# Cruachan Expansion Project – EIA Gatecheck Report

Version 1.0 February 2022

This Gatecheck Report has been prepared to summarise work undertaken by the project team since the submission of the Cruachan 2 Environmental Impact Assessment Scoping Report to the Scottish Ministers in June 2021 and the adoption of an EIA Scoping Opinion on 29th October 2021. The purpose of this report is to explain how the design of the Proposed Development has evolved in response to Scoping responses and to confirm how design and assessment matters raised in EIA Scoping responses are being addressed. The report describes how EIA Design Freeze for the Proposed Development has been reached and outlines the approach to environmental mitigation development, taking account of EIA Scoping responses and local community feedback from the public exhibitions held in July, November and December 2021.

# Appendix A Figure 4: Access Road Plans

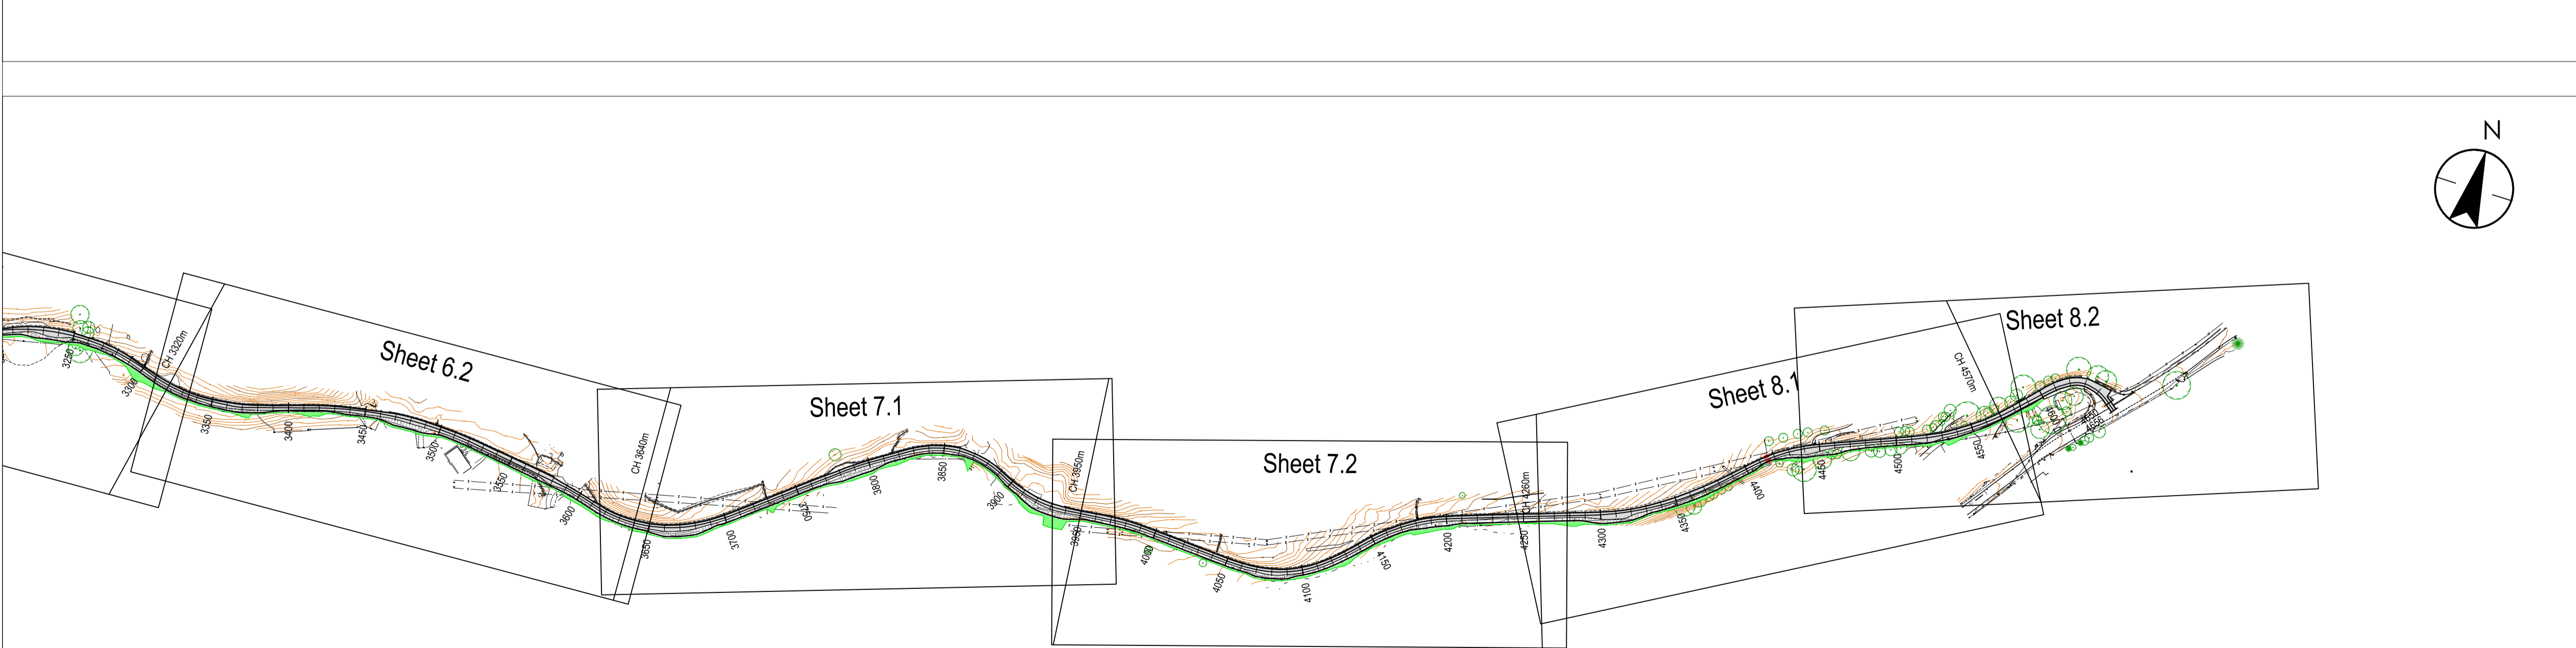
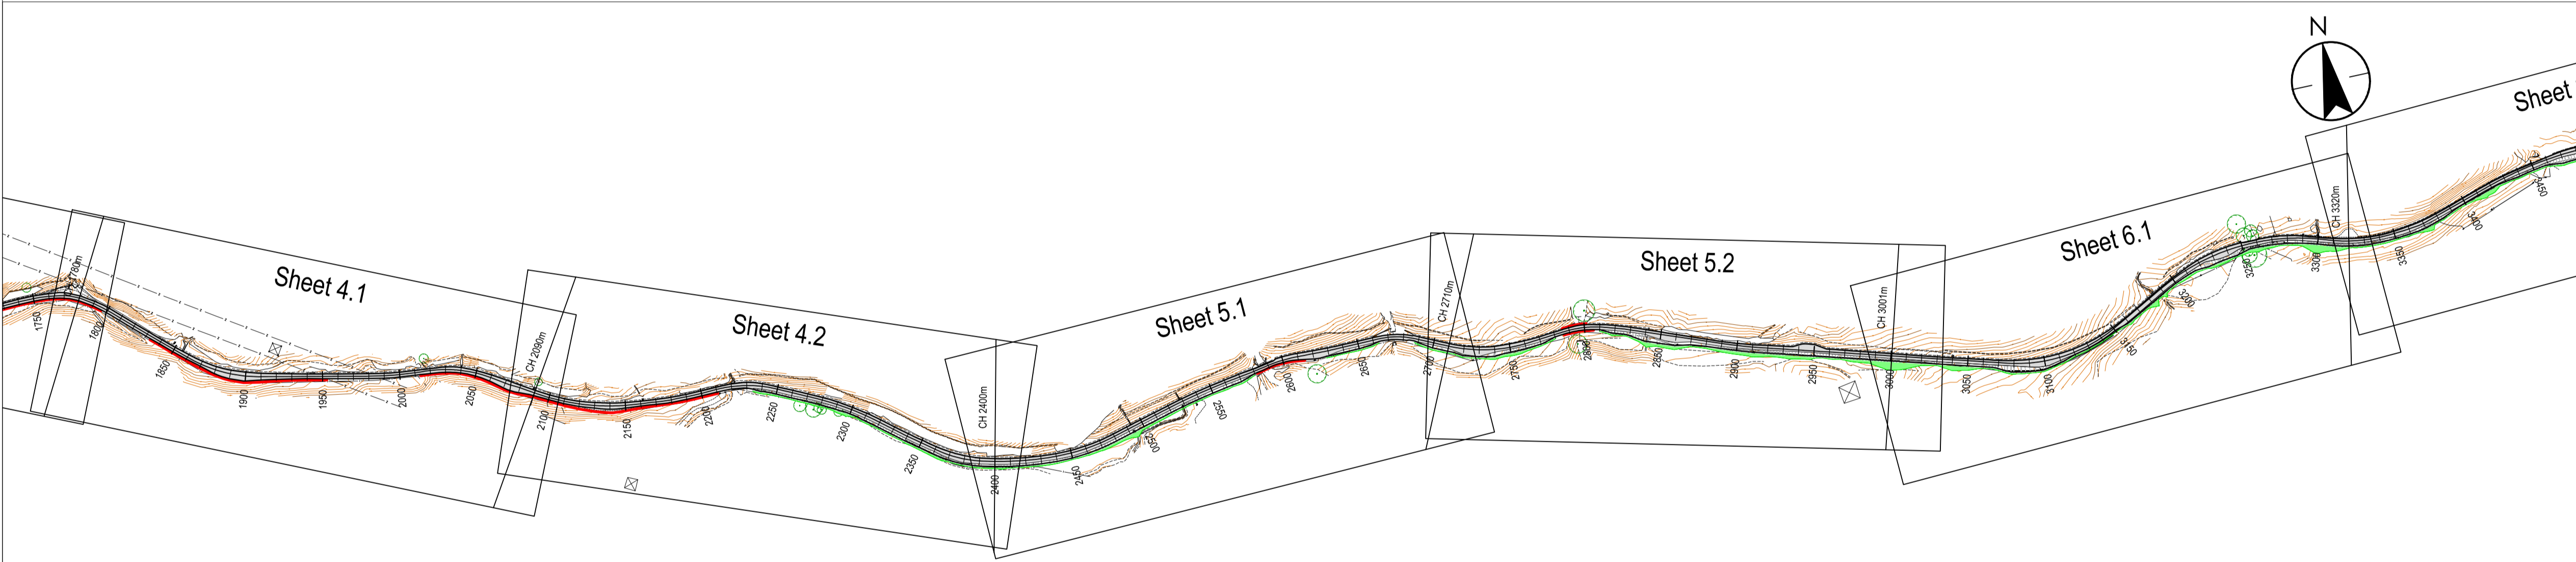
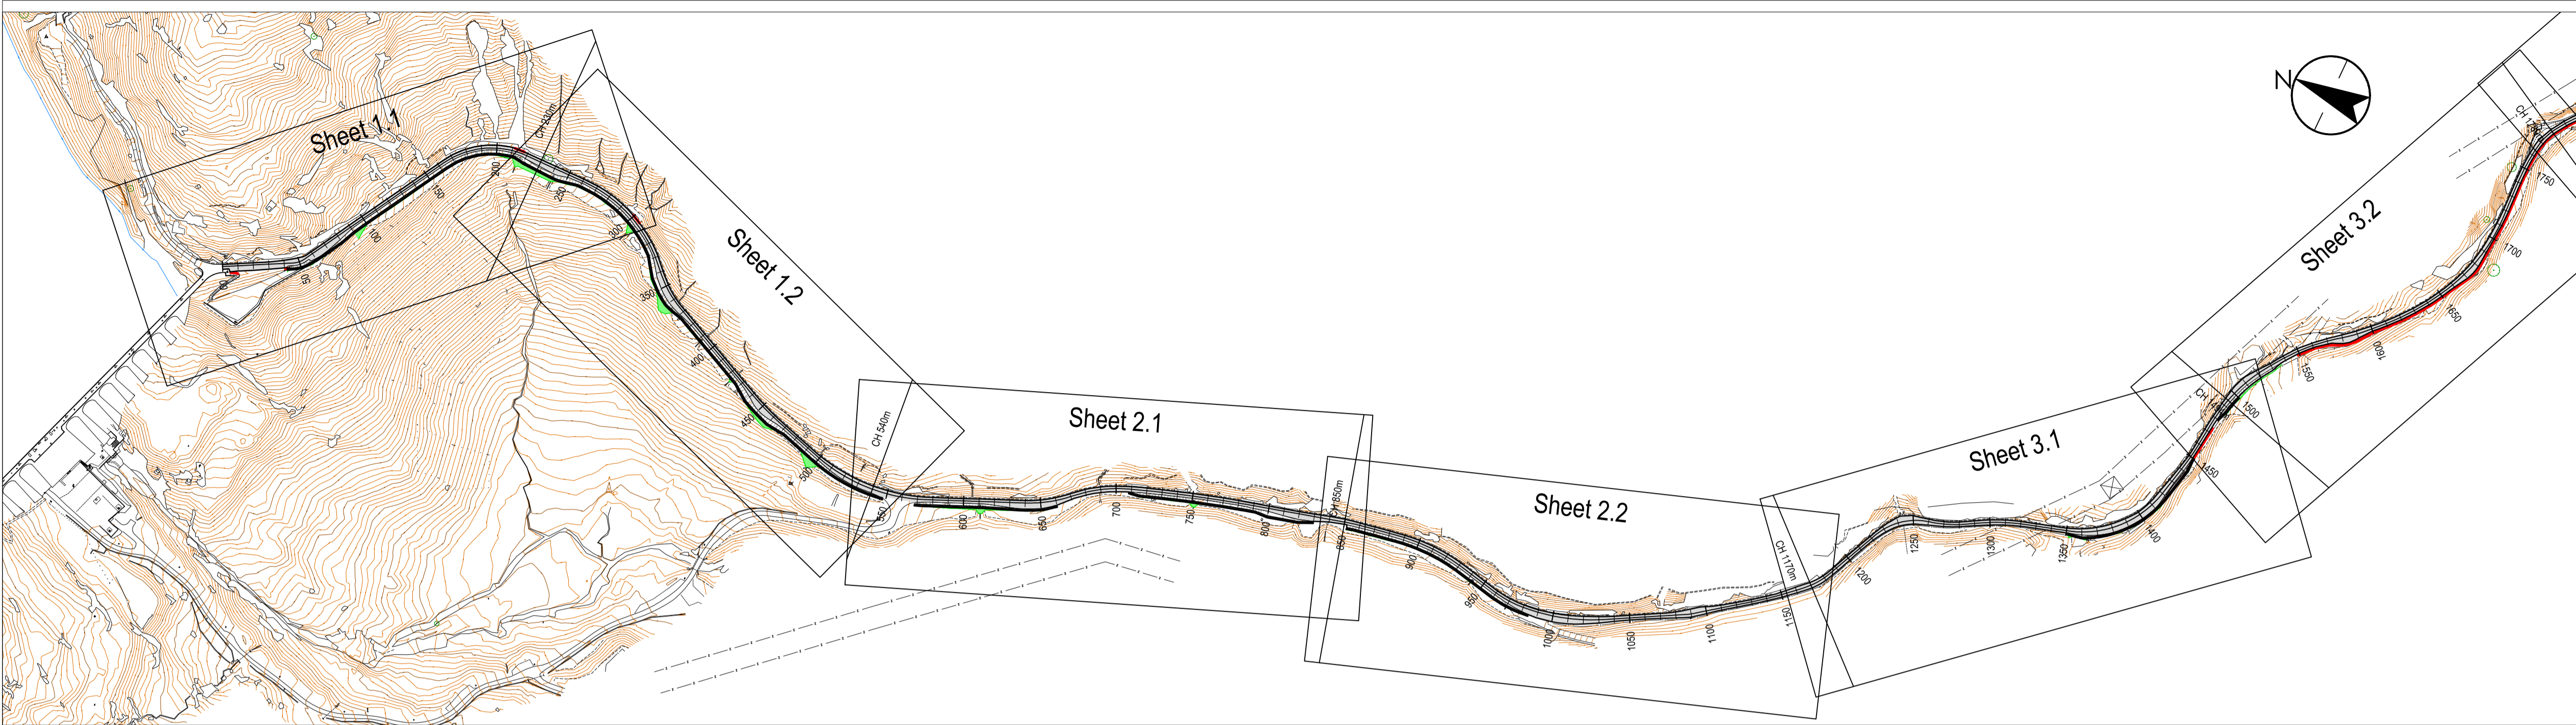
Access road from A85 to dam	Unsure of nature or extent of road widening and included the potential to use the access road for the removal of spoil.	<p>The extent of road widening has now been clearly defined and is presented on Appendix Figure 4. Where possible (in the upper part of the access road close to the dam and the lower part of the access road close to St Conan's Road) the access road will be widened to 4.7m to allow 2 way traffic and HGV movements. However, the middle part of the access road is significantly constrained. Therefore, there will be a need for traffic management in this middle part of the access road. This will consist of traffic lights and a one-way system with HGV queuing.</p> <p>Given the need for this traffic management, as well as feedback from the initial consultation events regarding concerns over vehicle movements</p>

Element of Project	Scoping Report Assumptions (June 2021)	Revised Design (February 2022)
		on St. Conan's Road, The Applicant has committed to not removing any spoil or rock from the upper works via the Dam access road. Instead, all spoil generated by the upper works will be dropped down the main tunnel shaft and penstocks and removed via the main access tunnel at Loch Awe.
Lower Works (A85 Diversion)	The Scoping Report indicated that to construct the main access tunnel, the A85 would need to be diverted temporarily onto the quayside structure built in Loch Awe.	The A85 is now proposed to be temporarily diverted via an existing car-parking layby (also on the A85) to the east of the Cruachan 1 plant at the Falls of Cruachan railway station.  This will allow a simpler and safer diversion, a more straightforward construction process and reduce the likely duration of the diversion to a period of 3-4 months, reducing disruption to traffic on the A85. Alternative car parking facilities will also be provided at the Cruachan Visitor Centre whilst these temporary works are underway
